National Mall and Memorial Parks

Lincoln Memorial Rehabilitation Environmental Assessment

Consulting Parties Meeting Notes

February 21, 2018

PROPOSED ACTION
ALT. B

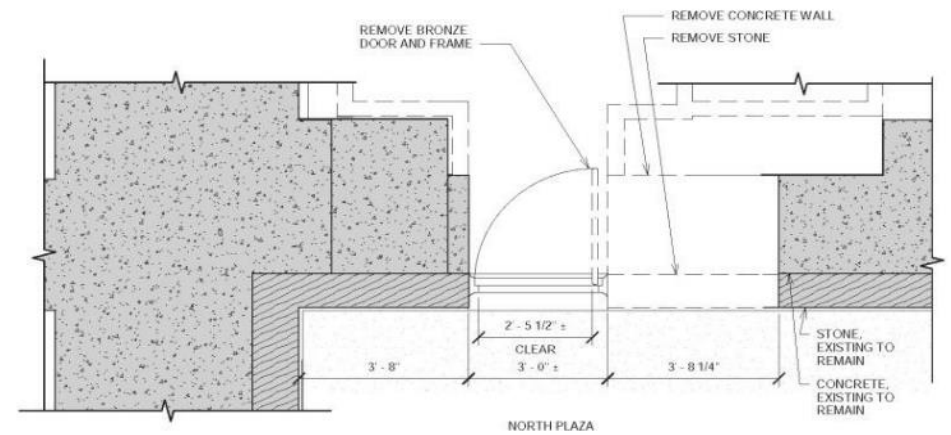
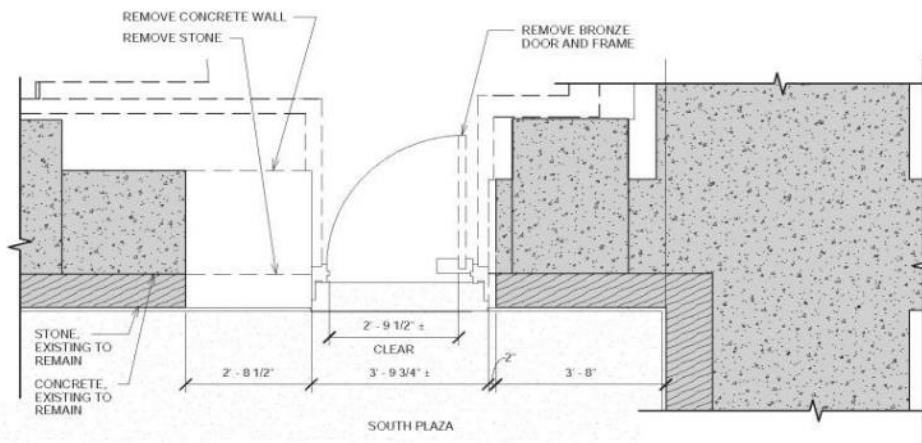
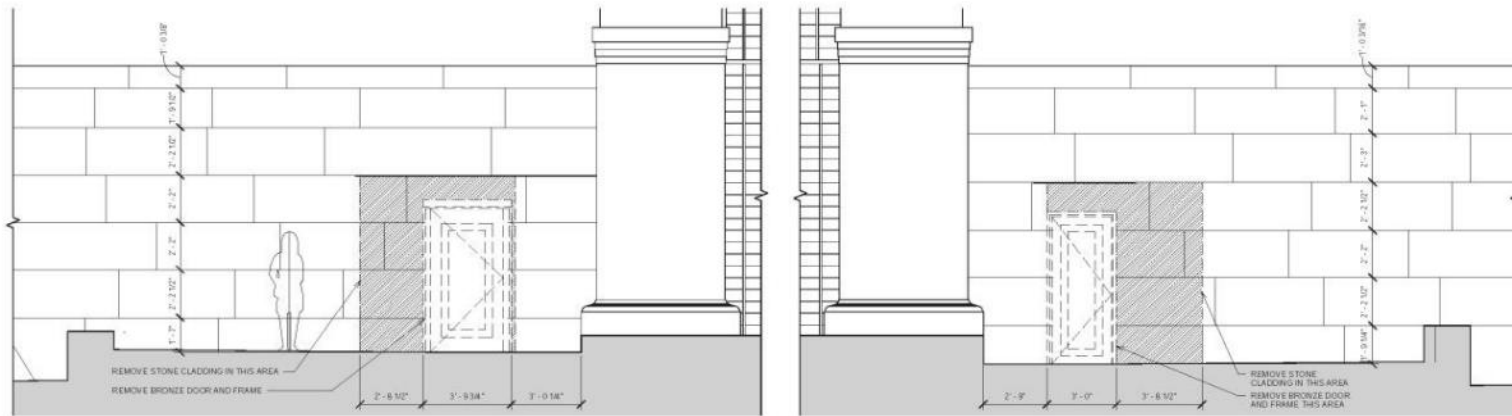
- Question/concern: Will there be change to historic materials visible to the public for installation of the second elevator? Will the existing door on the chamber level need to be modified?

- Response: The elevator will use the existing space in the north side of the chamber level and will use the existing door, which meets code. All changes to the historic material will be in areas not visible to the public. The elevator and associated vestibule will mirror the existing elevator and vestibule.

ALT B: 72' OPENING (2x36") DEMO PLAN, EAST ELEVATION

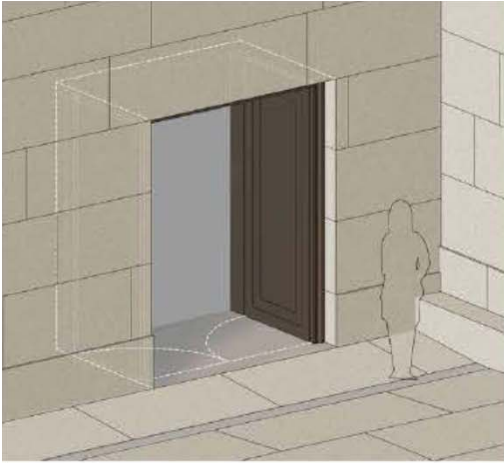
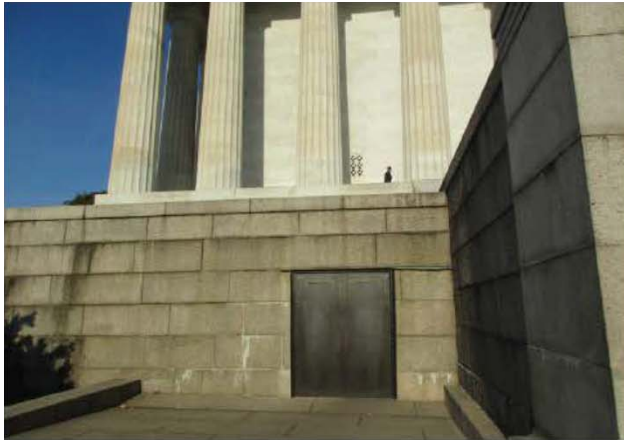
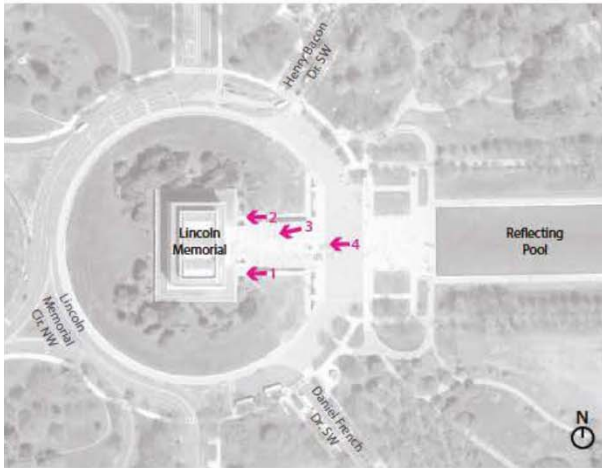
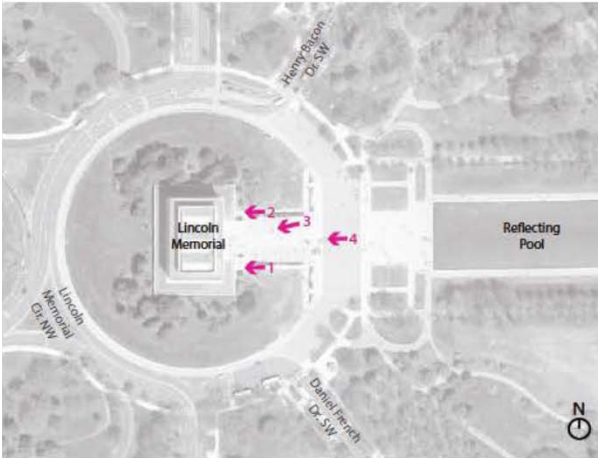
- Question/concern: How will the larger doors and second elevator affect how visitors access and experience the memorial? How will it affect the procession up the stairs? A concern was raised that visitors who enter the undercroft first may choose to take the elevator up to the chamber level rather than walking up the stairs. A related concern was that visitors in the chamber will not know there is an exterior door to the undercroft and will take the elevator by default.

- Response: While visitor trends are difficult to predict because the undercroft will be a new experience, the NPS expects that most people will continue to use the stairs to access the chamber level due to high visitation, even with two elevators. The NPS also expects the majority of visitors to use the south door to access the undercroft due to its proximity to the parking area. The visitor experience in the undercroft is expected to average about 10-15 minutes, which was estimated based on current visitor trends. The NPS expects to have to adapt to changes in visitor use and may add more park rangers and/or signage to direct visitors to the stairs rather than the elevator when possible.
